SUBDIVISION REVIEW SHEET**CASE NO.:** C8-2020-0167.0A**COMMISSION DATE:** February 7, 2023**SUBDIVISION NAME:** Blackwood's Resubdivision**ADDRESS:** 1801 Lightsey Road**APPLICANT:** Noel Blackwood**AGENT:** Wheels and Water (Katie Kham)**ZONING:** SF-3**NEIGHBORHOOD PLAN:** NA**AREA:** 1.106 acres**LOTS:** 4**COUNTY:** Travis**DISTRICT:** 5**WATERSHED:** West Bouldin Creek**JURISDICTION:** Full Purpose**SIDEWALKS:** Sidewalks will be constructed along Lightsey Road**DEPARTMENT COMMENTS:**

CITY OF AUSTIN –DEVELOPMENT SERVICES DEPARTMENT SUBDIVISION APPLICATION – MASTER COMMENT REPORT

PROJECT NAME: Blackwood's Subdivision
LOCATION: 1801 LIGHTSEY RD

SUBMITTAL DATE: January 9, 2023
FINAL REPORT DATE: February 2, 2023

VICINITY MAP
(NOT TO SCALE)

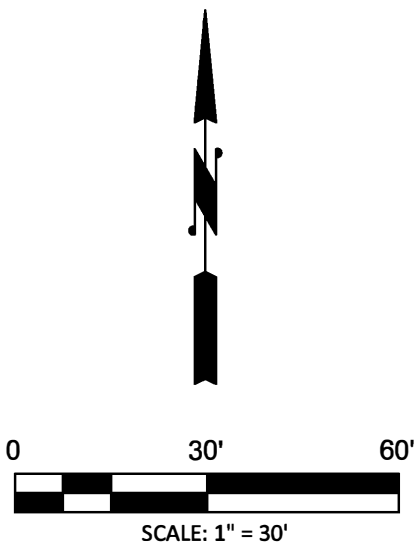
AD1. MENCHACA RD is the correct street name for this project §25-4-155

AD2. Please change the label for US HWY 290 so that W BEN WHITE BLVD appears above the label W US 290 HWY. W US 290 HWY should be enclosed within parenthesis and not be bold: W BEN WHITE BLVD (W US 290 HWY) §25-4-155

AD3. Please remove all forms of punctuation after abbreviating street types or directionals §25-4-155

FYI: MENCHACA RD is incorrectly labeled as MANCHACA RD
